Fox Hollow Painting 2016
Eugene Public School District 4J
Eugene, Oregon

CIP # 420.780.724

ADDENDUM NUMBER ONE

July 20, 2016

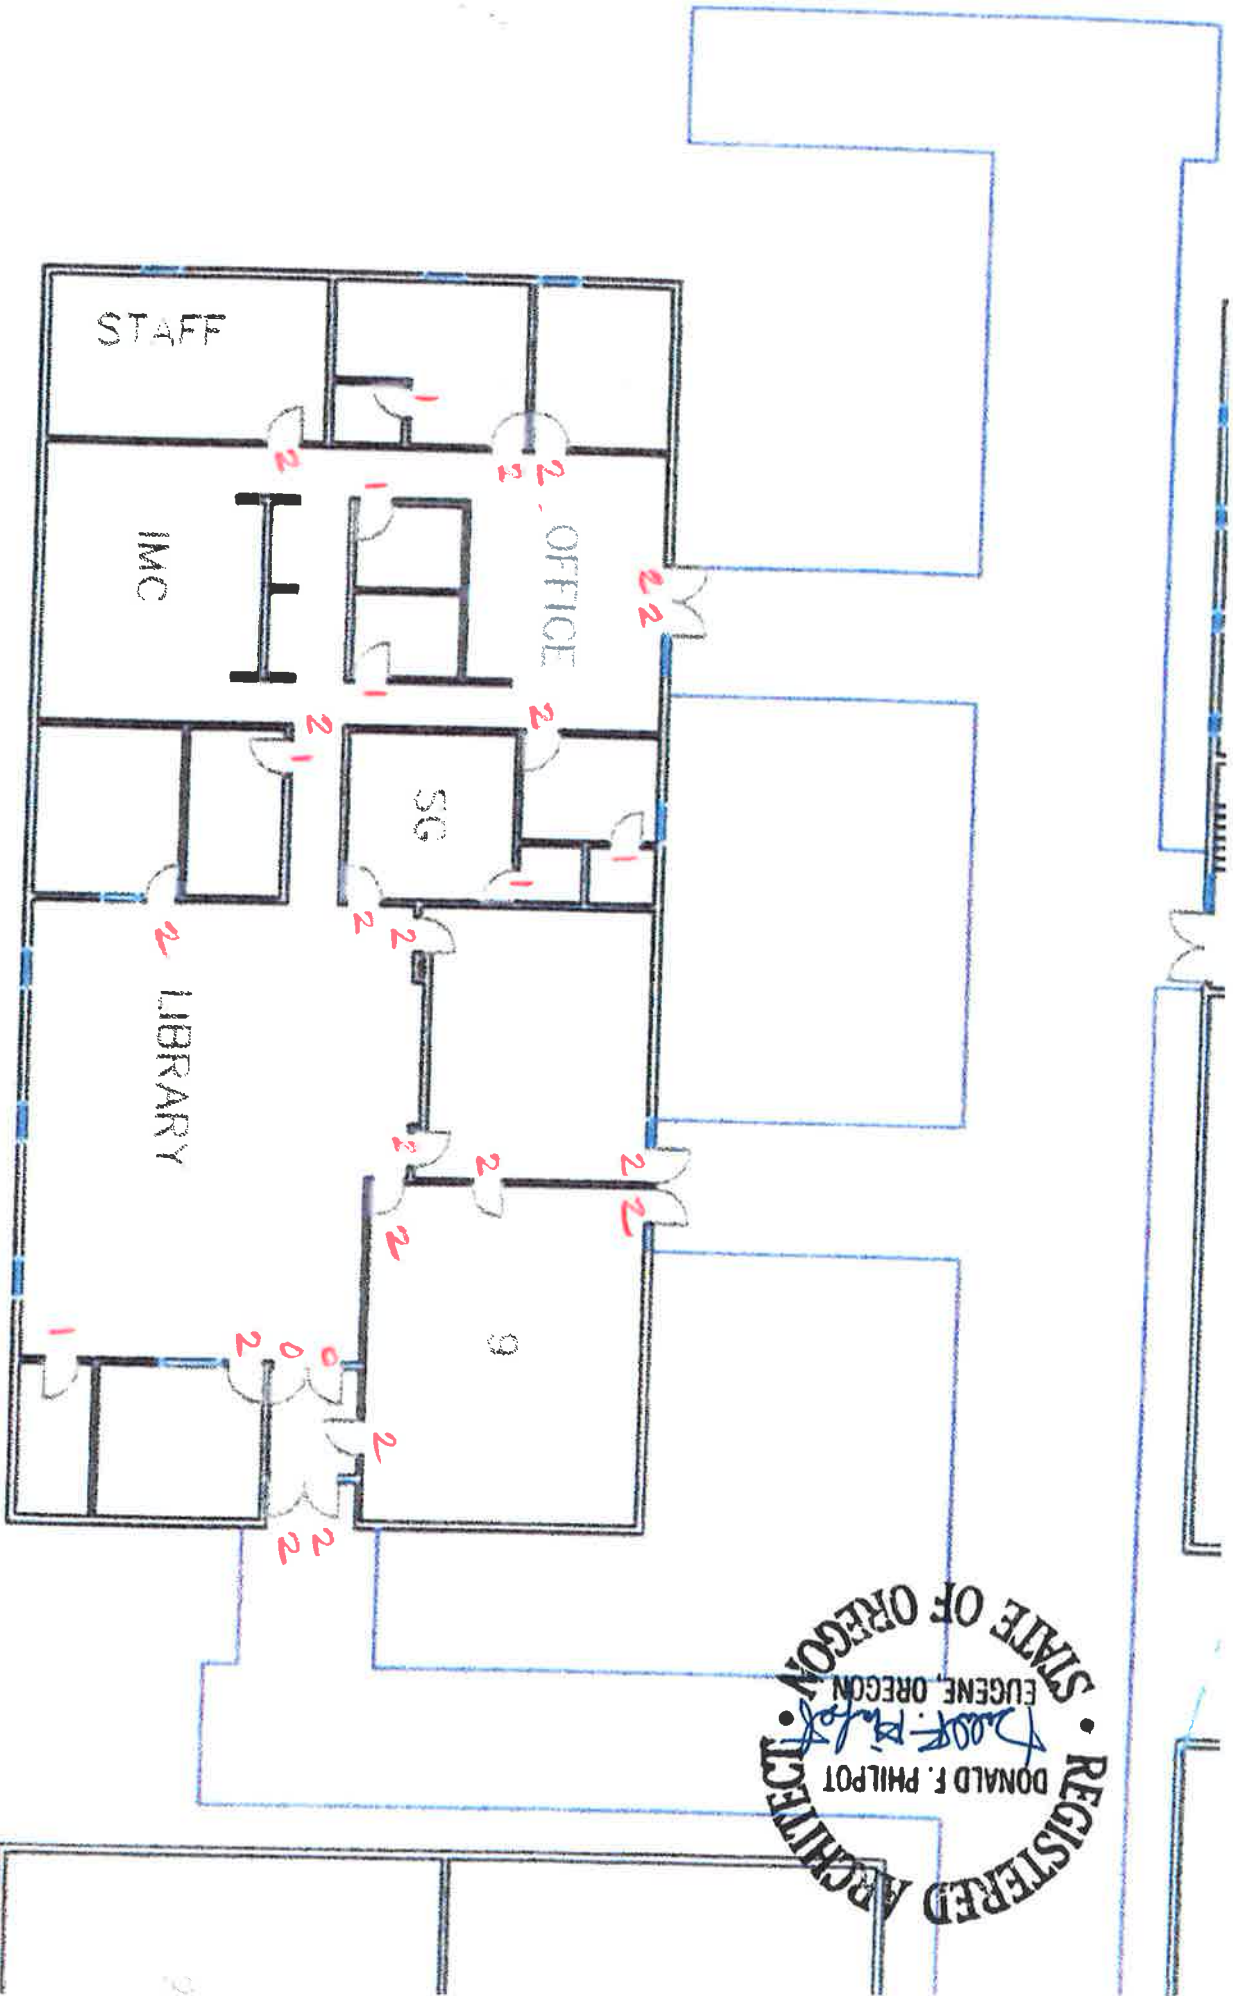
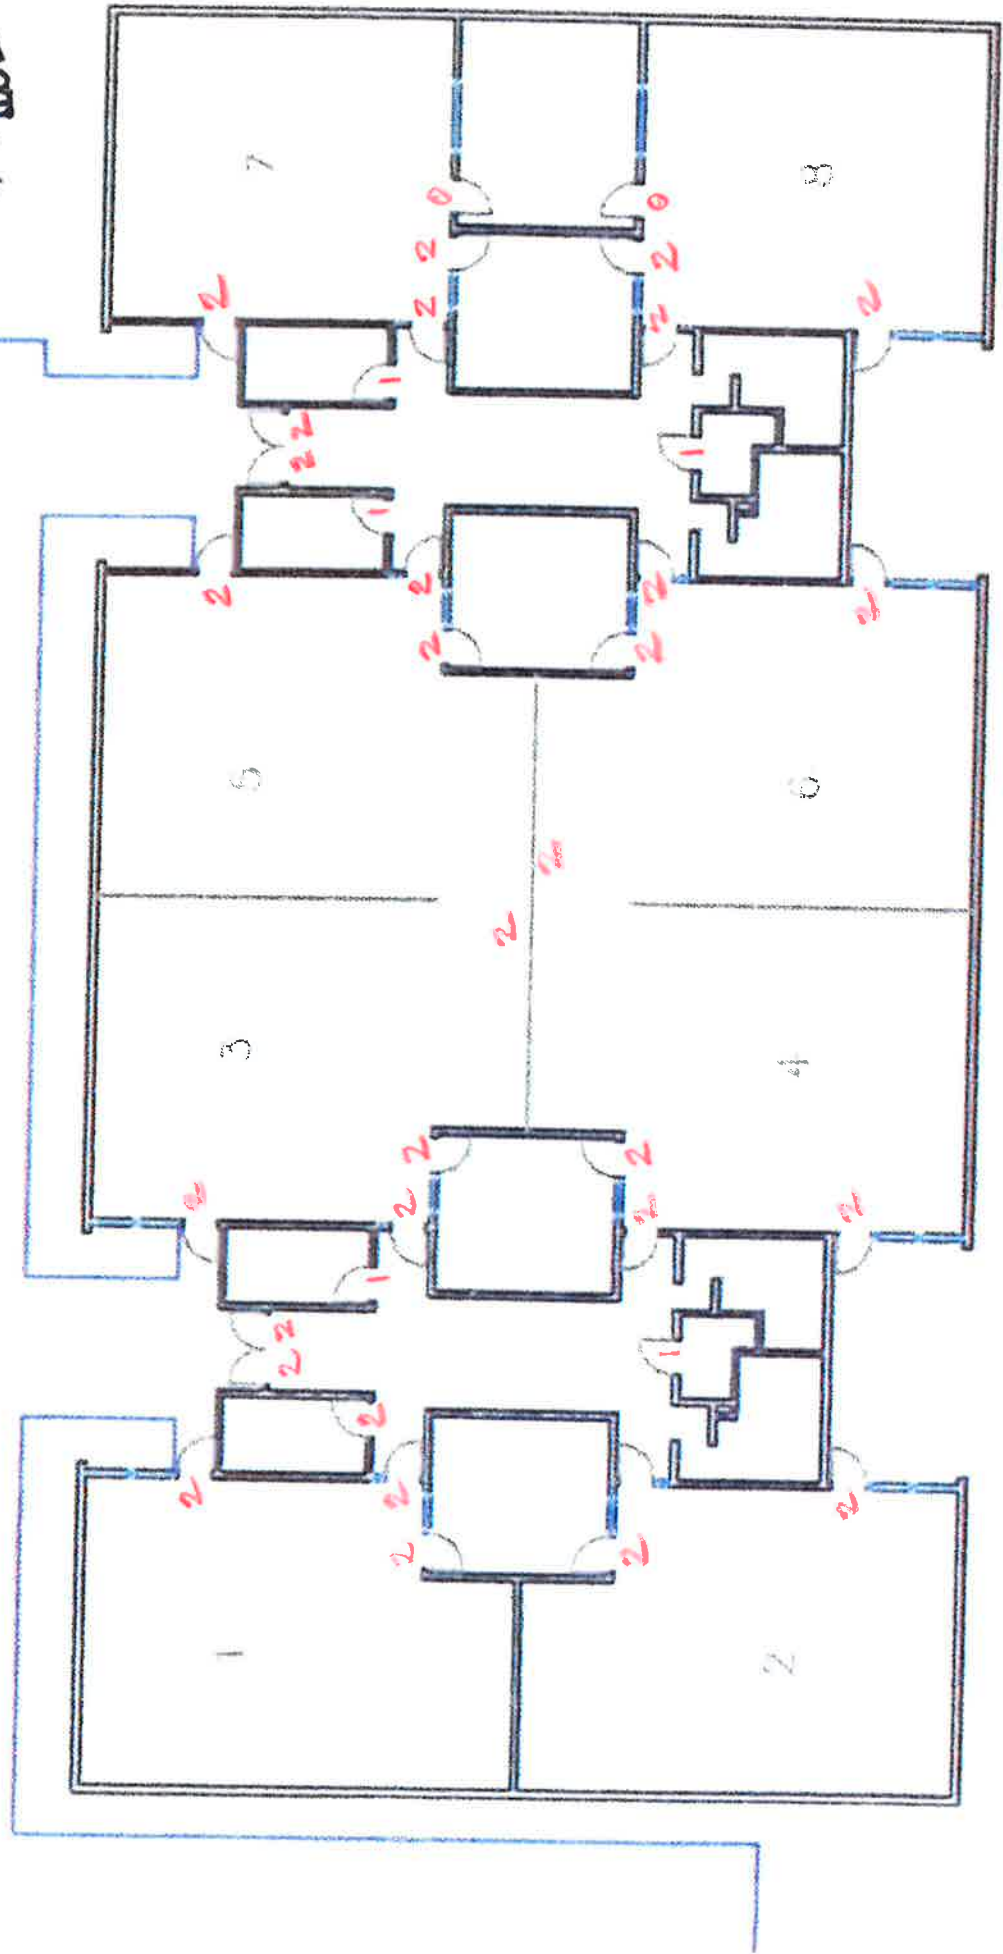
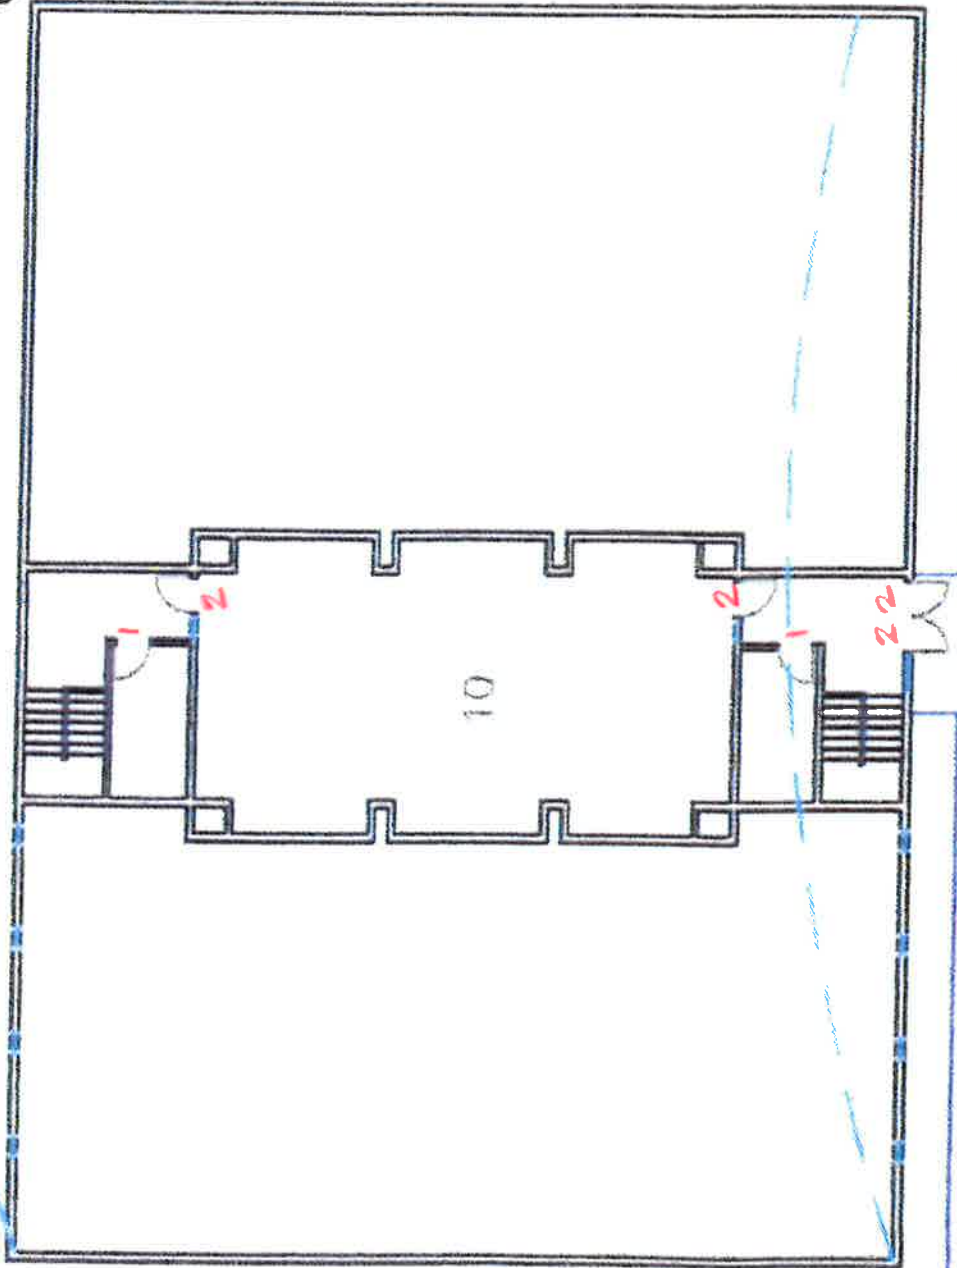
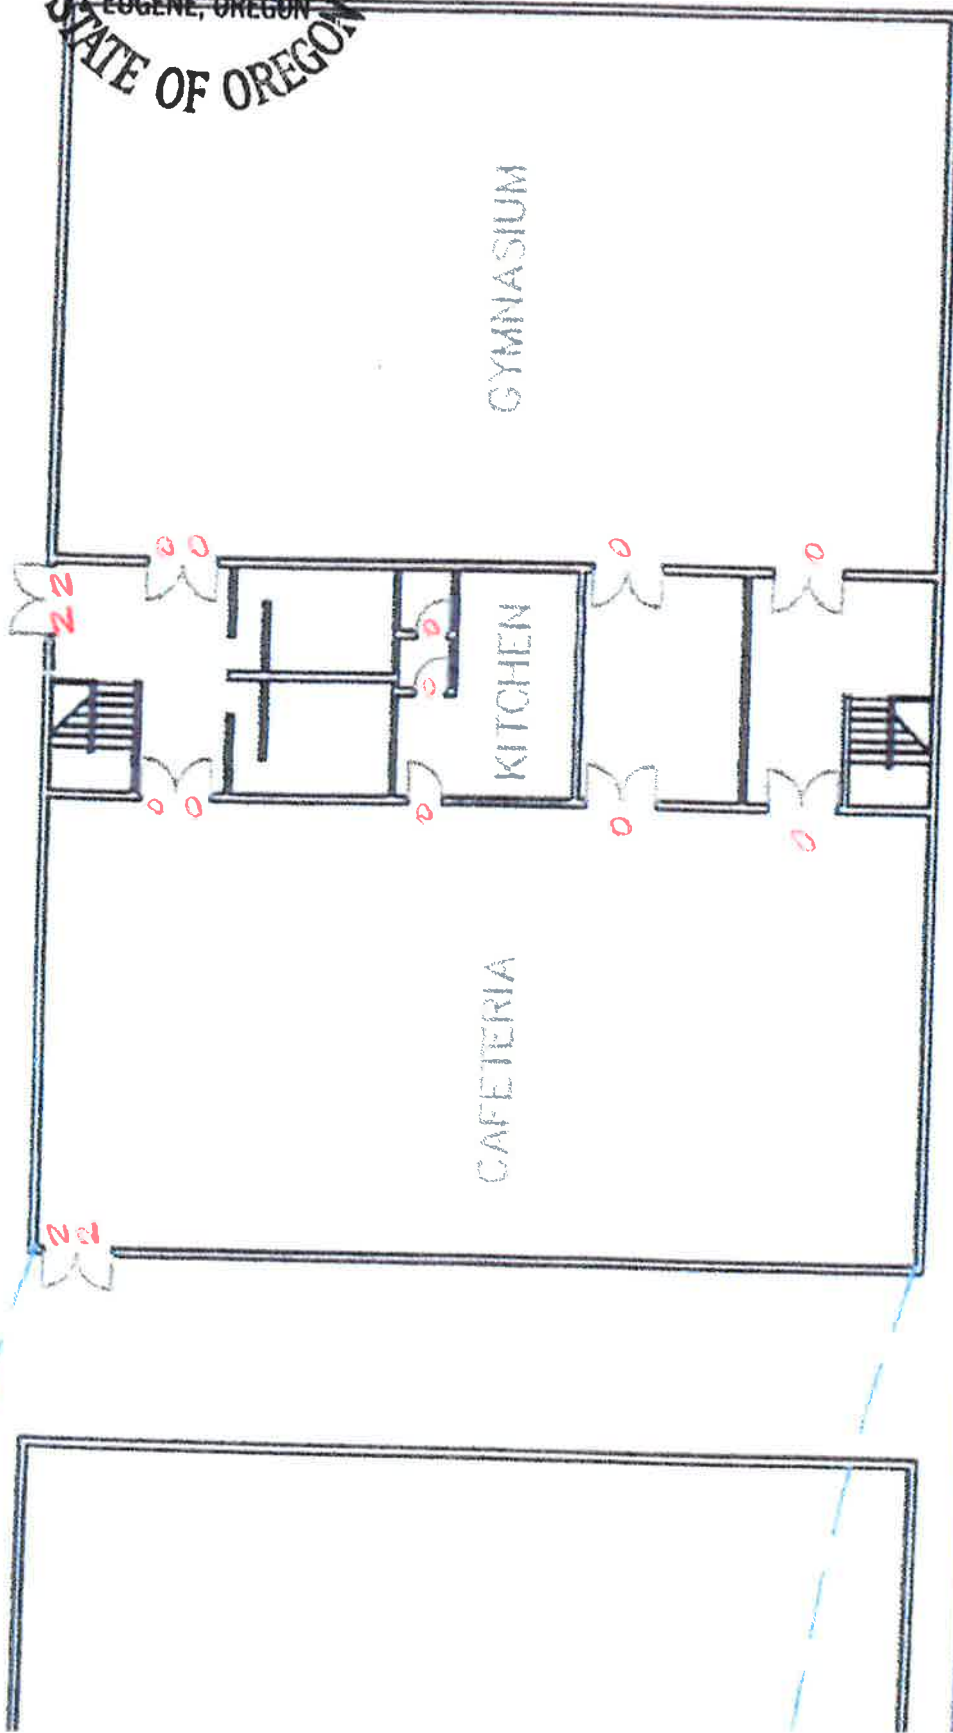
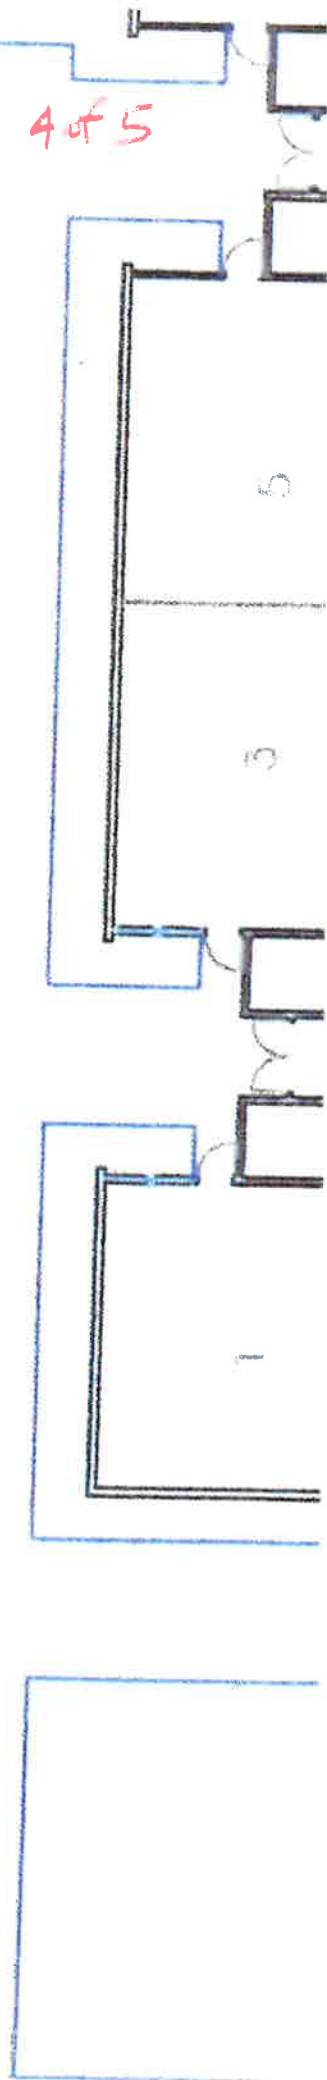
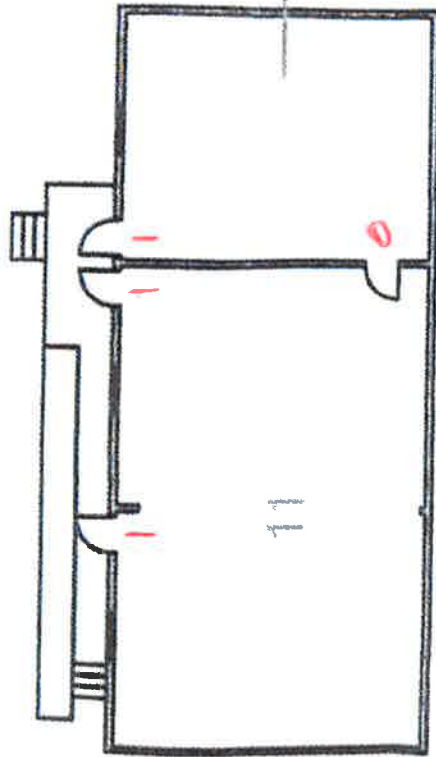
1. Attached are plans inventorying doors and frames to be painted.
Notations:
0 = Paint neither side of door, but paint the frames when frames are part of wall to be painted.
1 = Paint one side of door and frame.
2 = Paint both sides of door and frame.
